# Aquatic Ecology Supplementary Information

<b>Project name</b> Balliemeanoch Pumped Storage Hydro	<b>Client</b> ILI Pump Storage Hydro PLC	<b>Subject</b> CAR Application Request for Further Information	<b>Date</b> 27 February 2026
<b>Prepared by</b> [REDACTED]	<b>Checked by</b> [REDACTED]	<b>Verified by</b> [REDACTED]	<b>Approved by</b> [REDACTED]

Figure 1. Modelled flow duration curve for the River Awe (Figure 4.3.1 of the FEI report (Appendix C)).

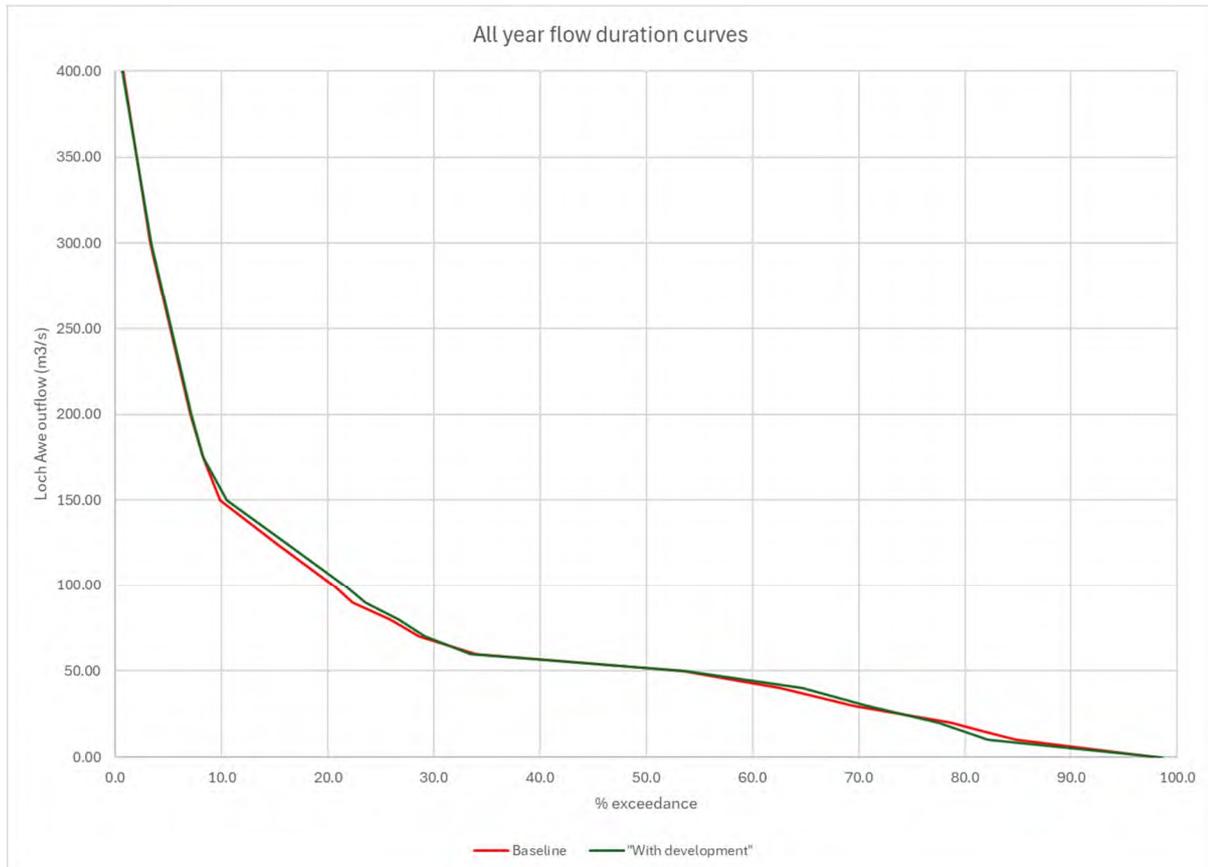
<p>2.4 Details of how the increased rate of change in loch levels with regard to the potential impact this has on migration (upstream and downstream) at Loch Awe Barrage have been considered.</p>	<p>Operational effects on aquatic ecology are discussed in Section 6 of the CAR License Supporting Documentation. Table 6-2 details the impacts and effect type (in relation to CAR) in line with WAT-RM-34.</p> <p>Operational effects on aquatic ecology are also assessed in Section 7.12.2.1 of Chapter 7 Aquatic Ecology of the EIAR (Appendix A of this TN). Since the assessment in the EIAR was completed, the size of the proposed head pond and associated infrastructure has been reduced (see Sections 2.2, 3.2, and 4.6 of</p>	<p>CAR License Supporting Document (Rev B September 2025)</p> <ul style="list-style-type: none"> <li>Section 6: Effects on Biodiversity - Aquatic</li> <li>Section 6.6 Assessing the Effects on Aquatic Biodiversity</li> </ul>	<p>Section 4.3 Aquatic Ecology of the FEI Report (Appendix C of this TN) has been excerpted in Section 3 below to provide clarity.</p>

The maximum change in water level that can result from the operation of the Development is being reduced from 1.2 m to 0.4 m due to the revised design. Modelling of the outflow at the Awe Barrage with the operation of the revised Development shows that changes in flow will be negligible (<5%) over the course of the year (Figure 1 below). The

baseline outflow rating at the barrage is estimated based on the change in volume of the loch and the calculated inflow to determine the total outflow from the loch, but it is uncertain what proportion of outflow involves pumping into Cruachan Headpond, abstraction into the Barrage hydro-electric intake, flow through the fish pass or any other compensation flow arrangement. Given the results of the current modelling approach for the revised scheme, the upstream migration of fish from the River Awe into Loch Awe will not be affected.

Given that the magnitude of the changes in water level on Loch Awe are being reduced by two-thirds, and that negligible changes in flows are expected from Loch Awe into the River Awe, the resulting Moderate adverse effect on migratory fish species in Loch Awe and River Awe is considered as being mitigated to a Minor adverse effect that is Not Significant.

**Figure 2. Maps showing the reduction in Headpond size (blue) as detailed in the FEI report (Appendix C of this TN)**

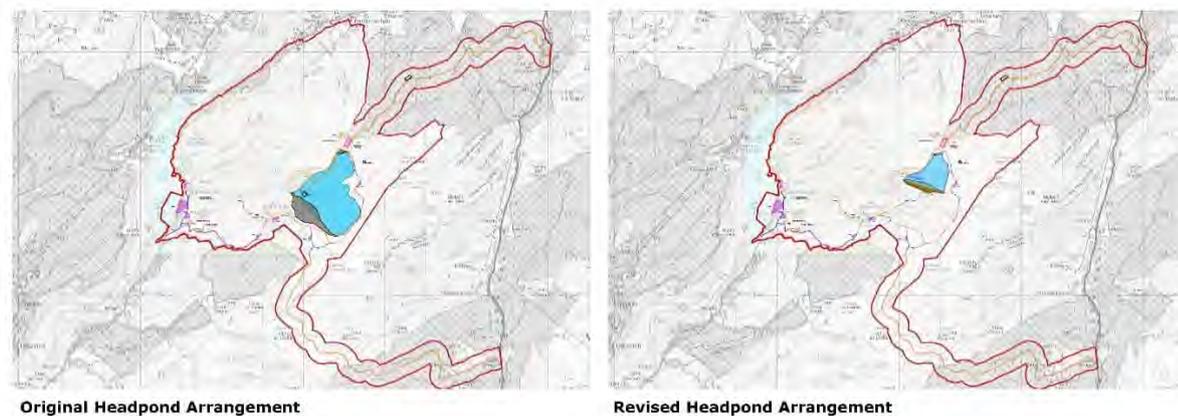
<p>2.6 Further details of the tributary diversion for the upper reservoir works, including species present, habitat present and the mitigation proposed.</p>	<p>Table 6-2 of the CAR License Supporting Documentation states that likely effects involving watercourse crossings for Temporary Access Tracks and temporary site compounds including diversion and culverting of watercourses, and temporary site drainage, including SuDs, settlement ponds, temporary ditches, and other drainage features are not included in the assessment as specified in the methodology, Supporting Guidance (WAT-SG-67).</p> <p>The loss of part of this watercourse is assessed as not resulting in the loss of habitat for notable aquatic species, see Section 7.9.3.3 of the EIAR Chapter 7 Aquatic Ecology.</p>	<p>CAR Licence Supporting Document (Rev B September 2025)</p> <ul style="list-style-type: none"> <li>Section 6: Effects on Biodiversity – Aquatic</li> </ul> <p>EIAR Chapter 7 Aquatic Ecology (Appendix A of this TN)</p> <ul style="list-style-type: none"> <li>Section 7.9.3.3 Construction of the Headpond and Headpond Embankments, Including Land Take and</li> </ul>	<p>Further comment provided for clarity in Section 3.</p>

Since the assessment included within the EIA was completed, the size of the proposed headpond and associated infrastructure has been reduced (see FEI Report (Appendix C of this TN)), resulting in a reduction in the length of diversion necessary for the tributary of Allt Beochlich. This further decreases the magnitude of any residual effects that were already assessed as being Low magnitude, to Negligible magnitude.

Figure 2 shows the original and revised design. Figure 3 shows the reduced section of tributary to Allt Beochlich (LA6) that is being lost as a result of the construction of the revised smaller headpond.
